GALES FERRY INTERMODAL

PRESENTATION TO LEDYARD PLANNING & ZONING COMMISSION DEC 19, 2024

Questions posed
by Ledyard Planning
& Zoning Commission
Members

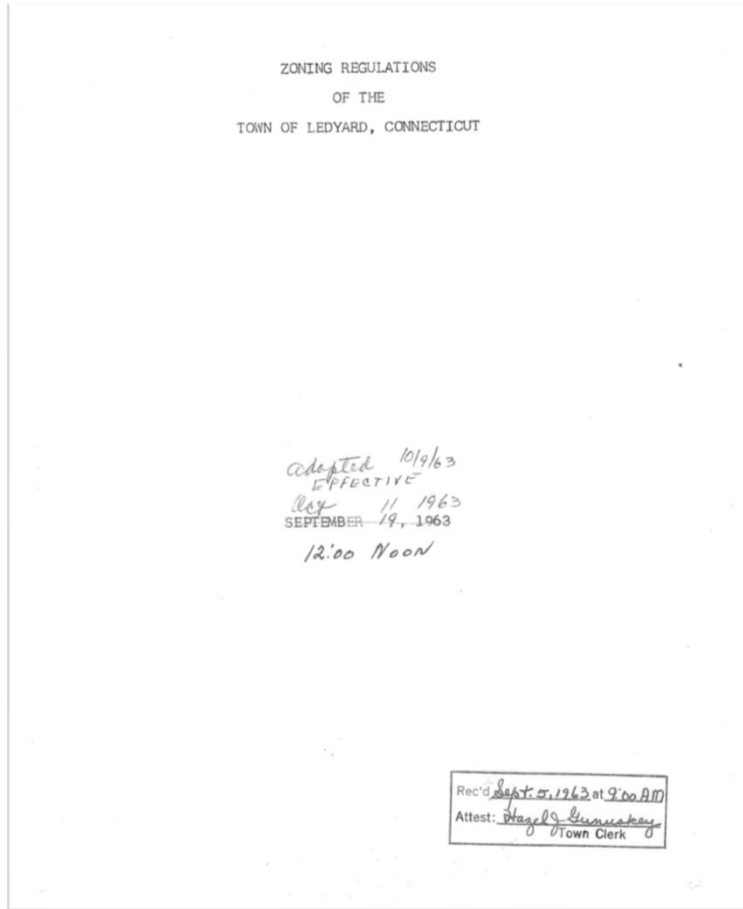
Who marked up the 1963 and 1975 Regulations as submitted by Eric Treaster at the end of his narrative from 12/5? Do we have a later set of regulations from around that time that shows the omission?

The Applicant assumes that this question refers to the attachment to Exhibit 204 in the Administrative Record which was submitted by Eric Treaster. The Applicant has no knowledge as to who has provided the notational comments. However, the Applicant is confident that they were added in conjunction with the current administrative proceeding and do not appear in the original record. The Applicant is attaching hereto, as **Exhibit A**, a copy of the 1963 original Zoning Regulations obtained from the Ledyard Town Clerk as well as, as **Exhibit B**, a copy of the applicable provisions of the Zoning Regulations subsequent to the 1975 amendment.

MAINE DRILLING & BLASTING, INC. – RESPONSE LETTER

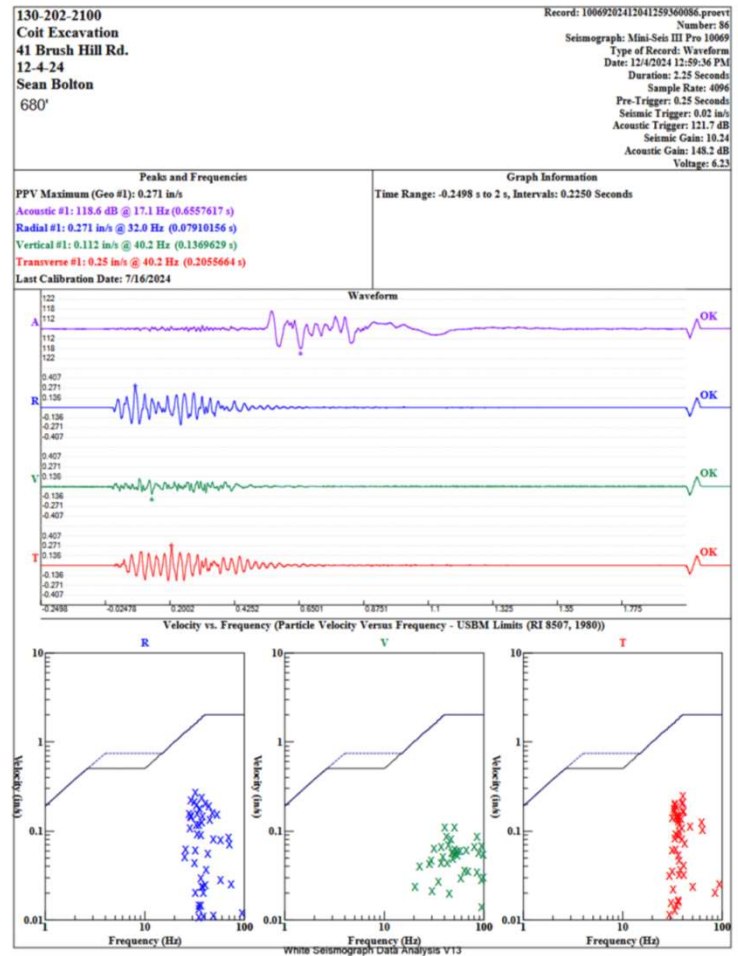
Maine Drilling and Blasting response to letter read from Lara Stauning from the 12/5 meeting: Is there a report to corroborate their comments in regards to vibration levels? Does this report come from monitoring equipment?

“Maine Drilling and Blasting response to letter read from Lara Stauning from the 12/5 meeting: Is there a report to corroborate their comments in regards to vibration levels? Does this report come from monitoring equipment?”

- All seismographs are calibrated yearly in accordance with NFPA 495 11.1.3 “Blasting seismographs used to monitor ground vibration and air overpressure shall comply with the ISEE document. “Performance Specifications for Blasting Seismographs.”
- All MDB employees setting up seismographs have been trained in the proper usage and set up according to NFPA 11.1.4 “Where used, blasting seismographs shall be deployed in the field according to the ISEE document, “Field Practice Guidelines for Blasting Seismographs.”
- We are currently blasting near Lara Stauning’s home at 41 Brush Hill Rd. Attached are the last 3 blasts on the Coyt project in Bozrah, CT.
12-4 680’ 0.271 ppv @ 32 hz
12-11 599’ 0.355 ppv @ 30.1 hz
12-16 619’ 0.444 ppv @ 34.1 hz

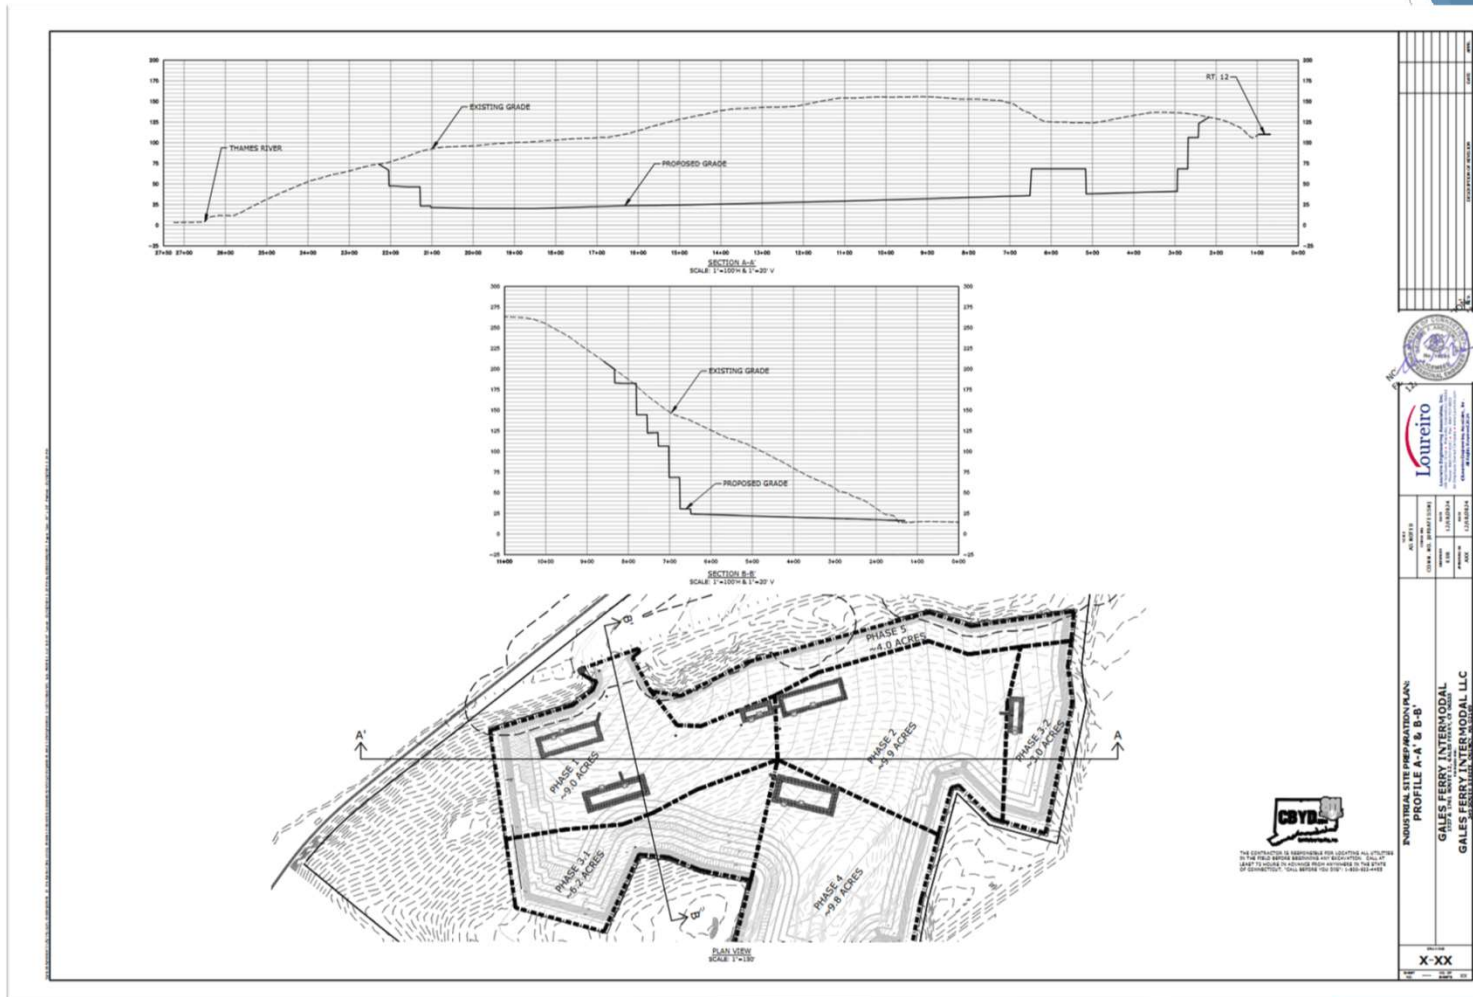
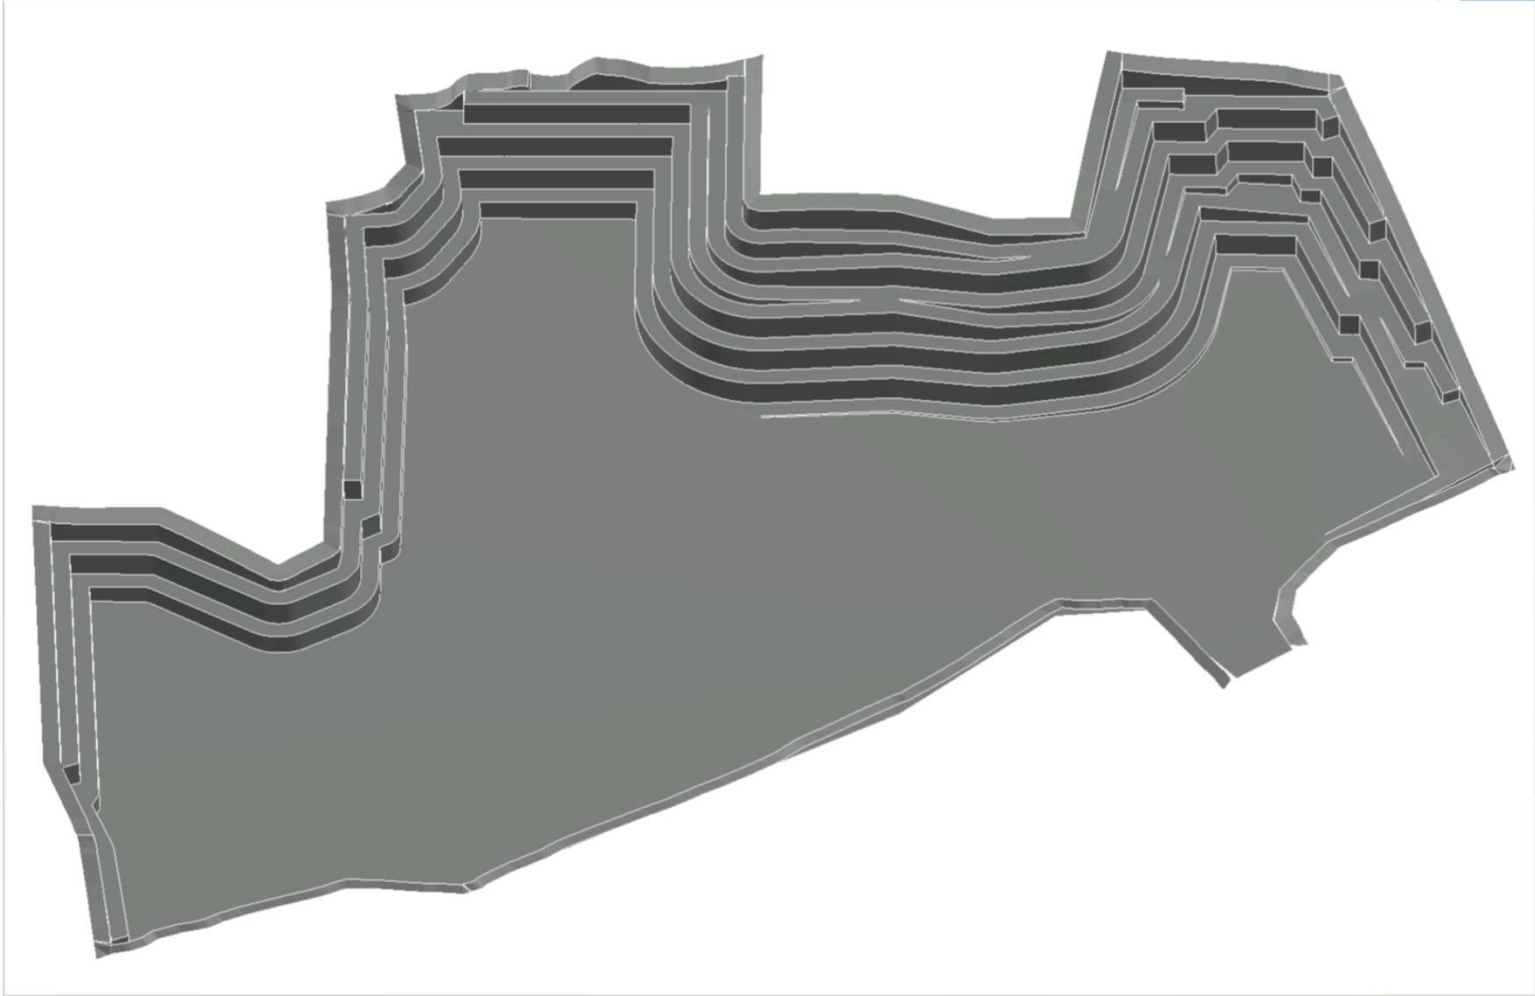
Please demonstrate in detail and in laymen's perspective the final grading depiction resulting from the regrading processes in this application. Please include the part of the property that extends from Route 12 and down to the Thames River. Please use existing plans as necessary and any other means to clearly show the resulting gradation.

See Section Views East to West (A-A') and North to South (B-B') attached prepared by Loureiro Engineering Associates, Inc. as well as a 3 dimensional drawing prepared by Loureiro Engineering Associates, Inc. to portray the final grading for the project after all 5 phases have been completed. Please note that cross section detail B-B' depicted on Drawing Sheet XS-1 evidences an elevation of 90 +/- at Route 12 with the finished grade ascending at Station 21+60 at the westerly edge of the excavation to elevation 100 +/-, a 10 foot rise in elevation. The finished grade then benches down to elevation 40 at the floor of the excavation which descends to the west to a finished floor elevation of 20 +/- at the westerly floor of the excavation at its west end. The approximate 1.5% finished grade has been designed to support future industrial development as represented by the Applicant.

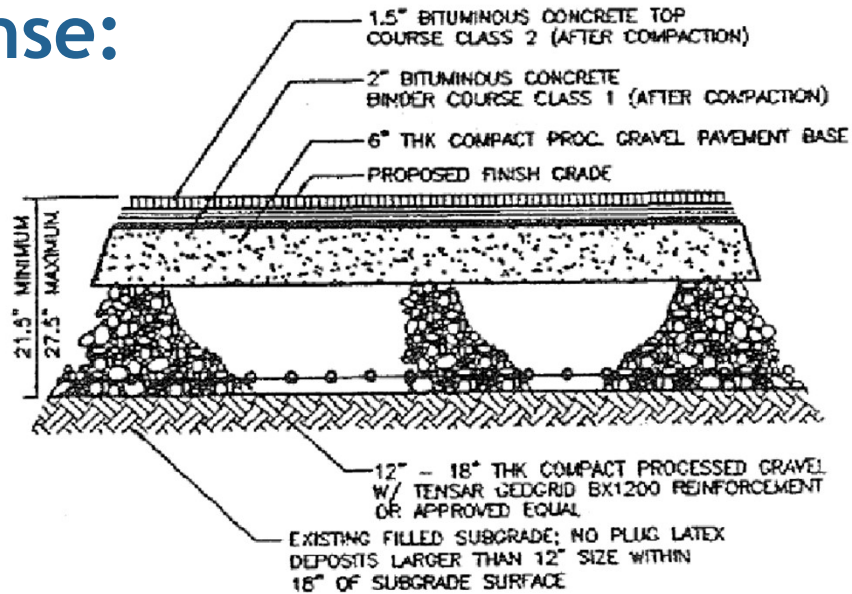
Please describe the contents/ characteristics of the capped area of the site as identified in the application as a remnant from the Dow era of use.

The asphalt cap design and specifications includes a combined thickness of asphalt (1.5 inches bituminous concrete top course and 2-inch bituminous concrete binder course) and other components of the constructed cap (compact process gravel, geogrid, etc.) varies between 21.5 and 27.5 inches across the 5.2 acre cap. It provides a robust barrier between potential receptors at the ground surface and impacted subgrade fill soils. The geogrid (Tensar® Geogrid BX 1200), provides geotechnical stability for the cover system, limiting differential settlement. A detail of the cap section is included below (extracted from the plan for the cap submitted to DEEP and approved).

As noted above, the existing cap was designed specifically to mitigate deformation of the underlying soils, specifically with the Tensar Geogrid and the substantial 12" to 18" compacted processed aggregate installed below the 6" pavement base and the asphalt surface. The design facilitated the continued use of the area by heavy industrial equipment. The construction of the additional "interim cap" constructed on the surface of the existing cap was specifically designed to provide protection to the underlying asphalt surface.

The interim cap was specifically designed with a minimum 6” base consisting of asphalt millings or processed aggregate, depending on the location which will distribute surface loading over a much larger area onto the existing asphalt surface, thereby providing significant protection of the underlying asphalt surface. Collectively, the interim cap upon the existing cap provides over 29” of gravel base and asphalt upon a geogrid, which far exceeds the requirements for any roadway constructed in the Town of Ledyard (Local Street - requires an 8” gravel subbase, 4” Processed aggregate base with 2” binder and 1 ½” Surface course). Providing such a firm and stiff base is the key to mitigating deformation and potential cracking of the underlying asphalt. As such, the interim protective cap needs to be looked at as a system along with the existing cap to ensure adequate protection, which is the basis for the design provided.
